Project	IEEE 802.16 Broadband Wireless Access Working Group < http://ieee802.org/16 >	
Title	Pilot allocations for 5,6,7,and 8 BS antennas	
Date Submitted	2004-11-12	
Source(s)	Qinghua Li, Xintian Eddie Lin, Shilpa Talwar, Nageen Himayat Intel Corporation	qinghua.li@intel.com Voice: +1-408-765-9698
Re:		
Abstract	Pilot allocations for 5-8 transmit antennas in optional FUSC and Band AMC	
Purpose	Adoption of proposed changes into P802.16e Crossed out indicates deleted text, <u>underlined blue indicates new text change to the Standard</u>	
Notice	This document has been prepared to assist IEEE 802.16. It is offered as a basis for discussion and is not binding on the contributing individual(s) or organization(s). The material in this document is subject to change in form and content after further study. The contributor(s) reserve(s) the right to add, amend or withdraw material contained herein.	
Release	The contributor grants a free, irrevocable license to the IEEE to incorporate material contained in this contribution, and any modifications thereof, in the creation of an IEEE Standards publication; to copyright in the IEEE's name any IEEE Standards publication even though it may includ

Figure 251d—Pilot allocation for 5-antenna BS for the optional FUSC and the optional AMC zones.

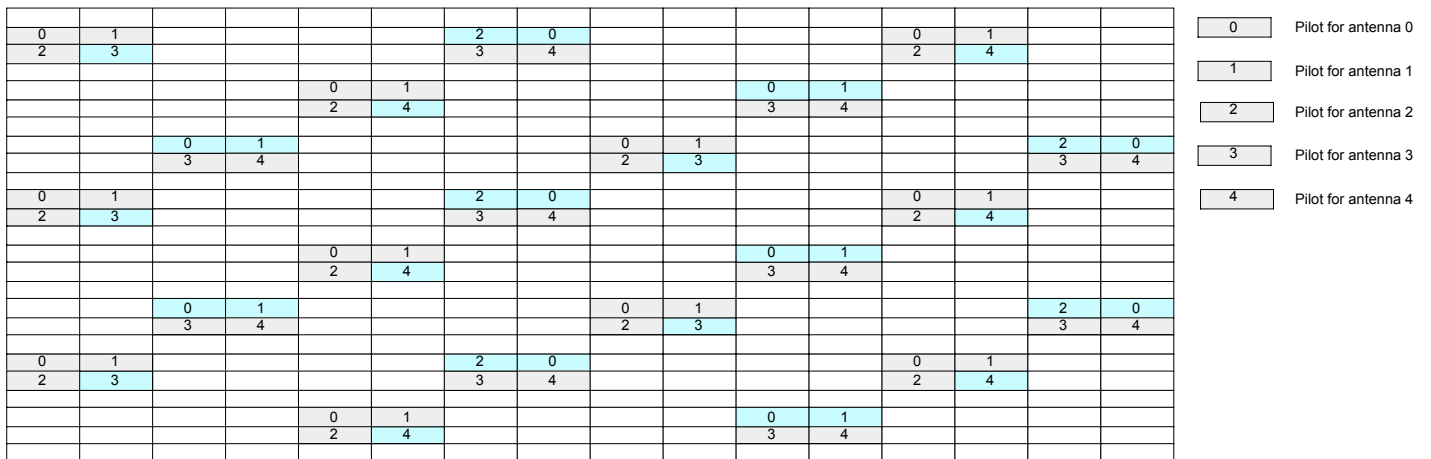
[Add the following text to section 8.4.8.3.1, 802.16e D5.]

[For 5-antenna BS, pilot pattern is shown in Figure 1.](#)

Figure 251e—Pilot allocation for 6-antenna BS for the optional FUSC and the optional AMC zones.

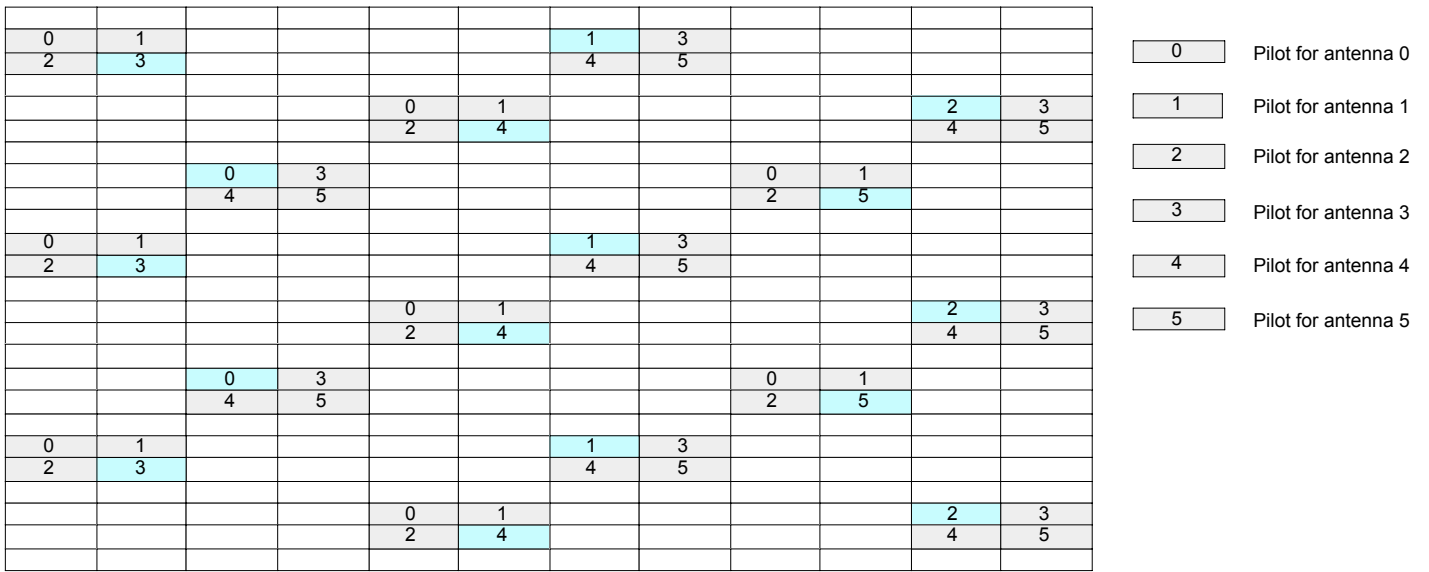
[For 6-antenna BS, pilot pattern is shown in Figure 2.](#)

Figure 251f—Pilot allocation for 7-antenna BS for the optional FUSC and the optional AMC zones.

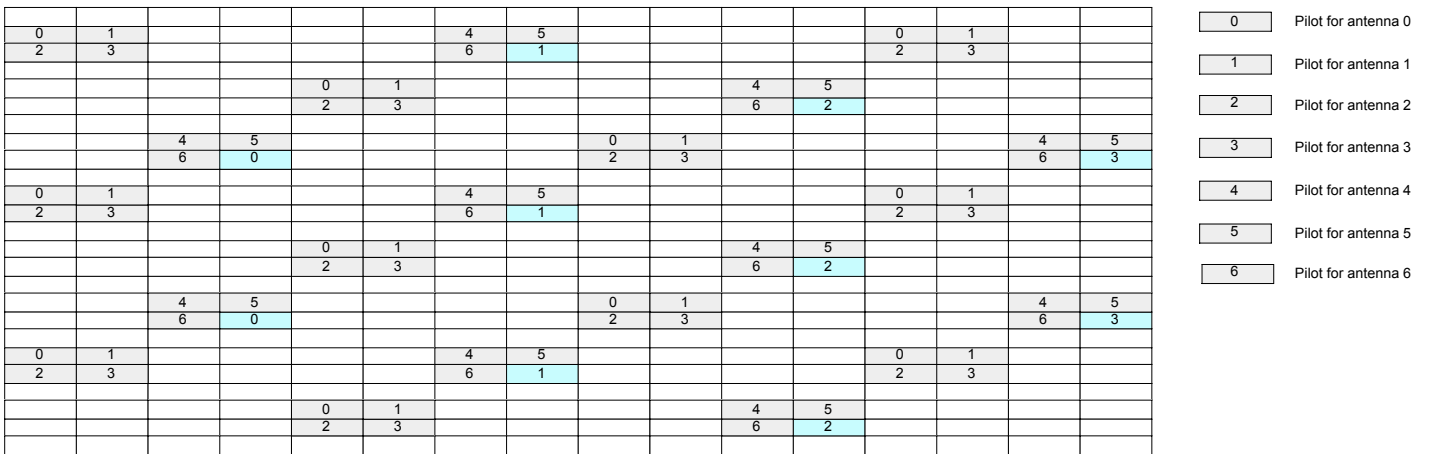
For 7-antenna BS, pilot pattern is shown in Figure 3.

[Figure 251g—Pilot allocation for 8-antenna BS for the optional FUSC and the optional AMC zones.](#)

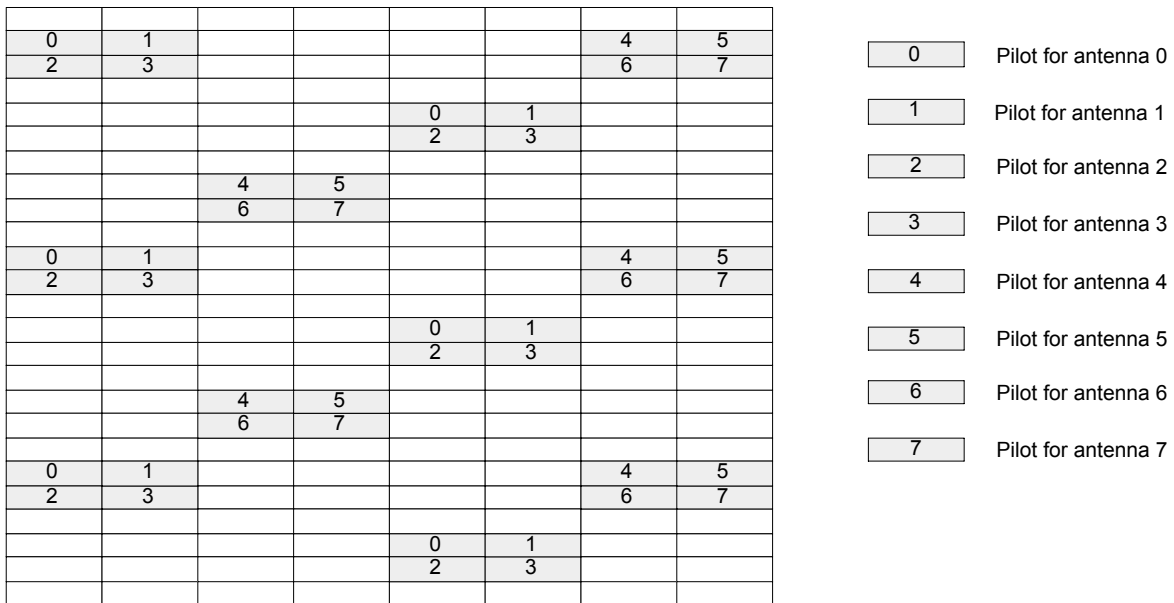
For 8-antenna BS, pilot pattern is shown in Figure 3.
